Project: IEEE P802.15 Working Group for Wireless Personal Area Networks (WPANs)

Submission Title: [SSA –UWB Implementation: an approach for global harmonization and compromise in IEEE 802.15.3a WPAN]

Date Submitted: [15 March, 2004]

1. Q&A with respect to the requests and concerns from MB-OFDM side

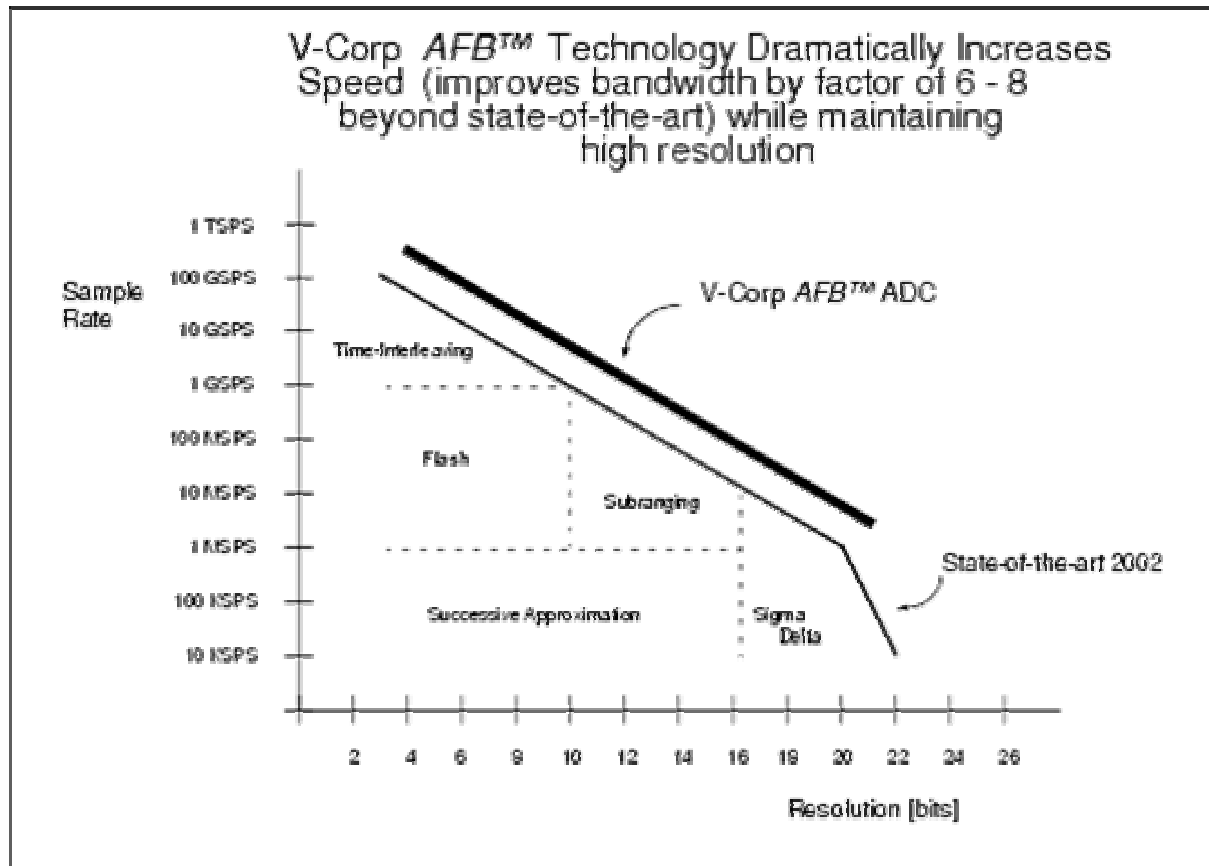
Q 1.a: “Is such a high-speed DAC feasible in Silicon?”

- First of all, CRL has implemented a test-bed with a software programmable digital architecture in order not to carry out SSA but to evaluate various UWB schemes with different parameters, e.g. waveforms, modulation schemes etc.

- Although SSA is feasible with a different architecture, we can also use the test-bed to analyze sensitivity of pulse shaping in spectral design.
- Honestly to reply for this question, using the test-bed we have decreased the bits and sampling rate starting from 71.2 GS/s to 8.9 GS/s (71.2, 35.6, 17.8, and 8.9 GS/s) with 4-bit or 3-bit quantization, in order to investigate the necessary requirement of DAC implementation.

- It has been tested that the DAC implementation of 3-bit or 4-bit, 8 GS/s is feasible and available, utilizing present digital signal processing (DSP) technologies. Some related information are provided in the following slides.

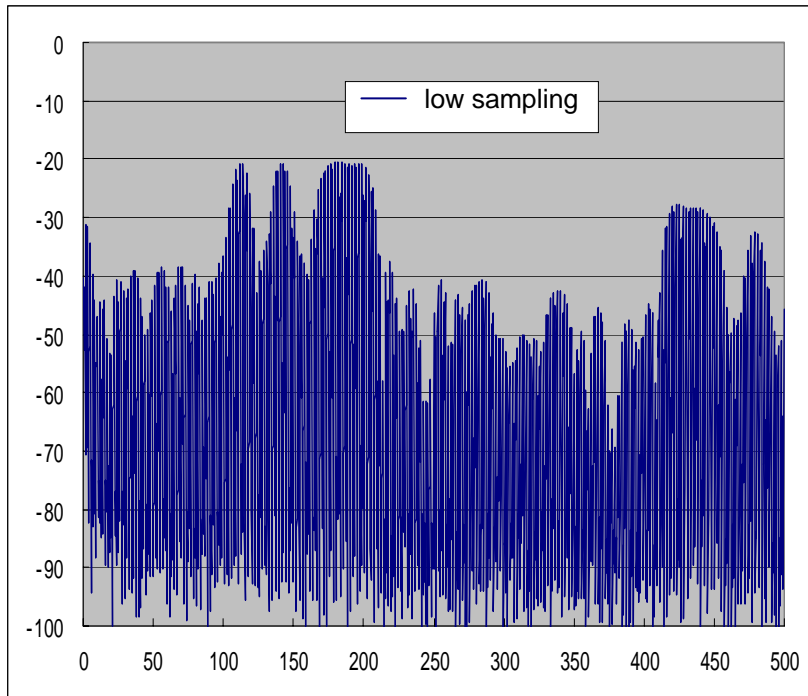
Q 1.b: “What is the expected power consumption and die-area of such a high-speed DAC?”

➤ The expected power consumption and die-area for the currently tested RF unit including the digital SSA pulse generator with DAC is totally 3.2 mm*mm and 63 mW, respectively.

Spectrum characteristics of SSA-UWB pulse wavelet
(Test-bed, low DAC sampling rate)

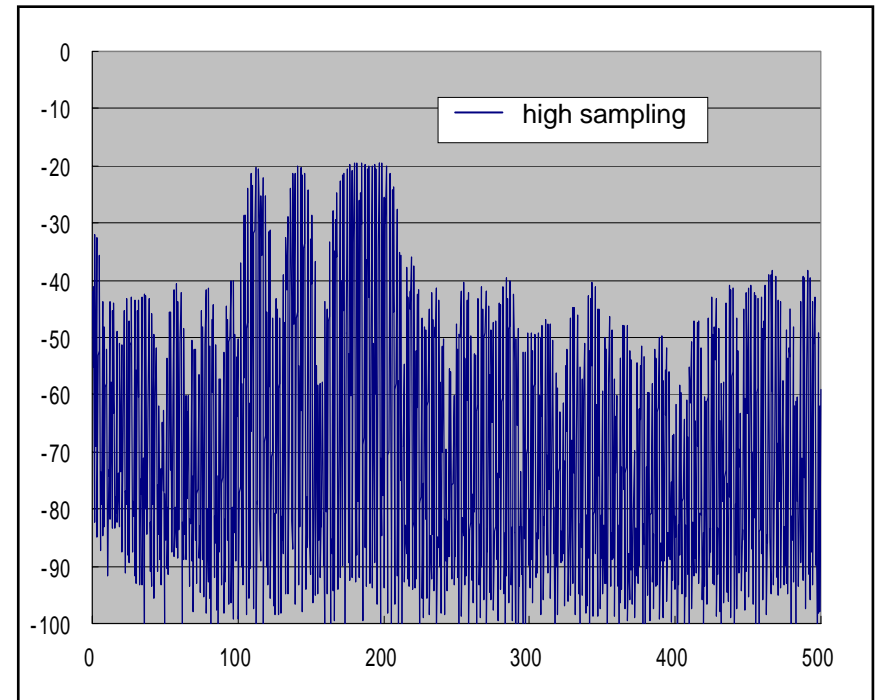
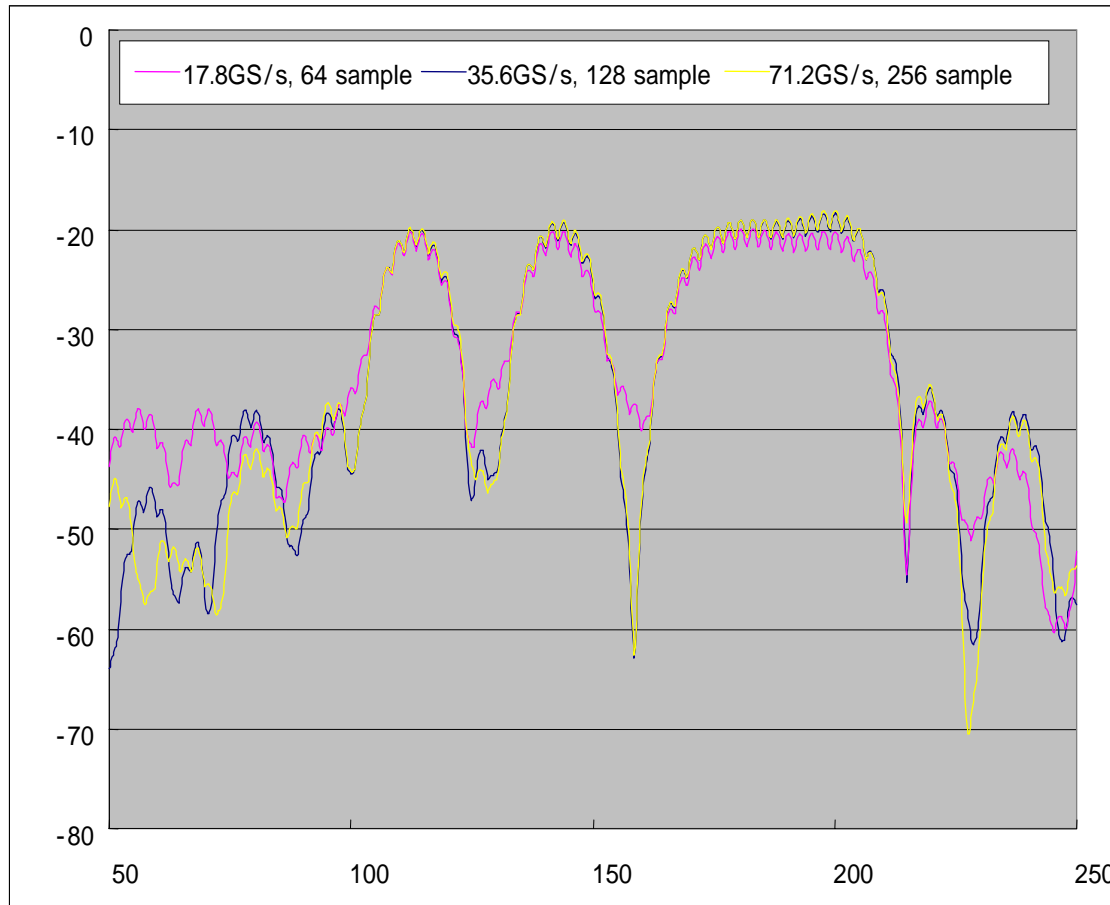
Q 1.c: “What is the trade-off between the DAC sampling rate and the depth and width of the notch that can be generated using SSA?”

- It has been observed that decreasing the DAC sampling rate had affected the depth of the required notch in the designed SSA pulse wavelet, namely, decreasing the sampling rate would lower the notch depth to some extent.
- Moreover, it has been found that the lower the DAC sampling rate (i.e. fewer quantization bits) we used, the more severe spectrum side-lobes of SSA pulse waveform would be produced.
- According to CRL's Test-bed results, using quantization <3-bit would cause severe spectrum side-lobe problem.
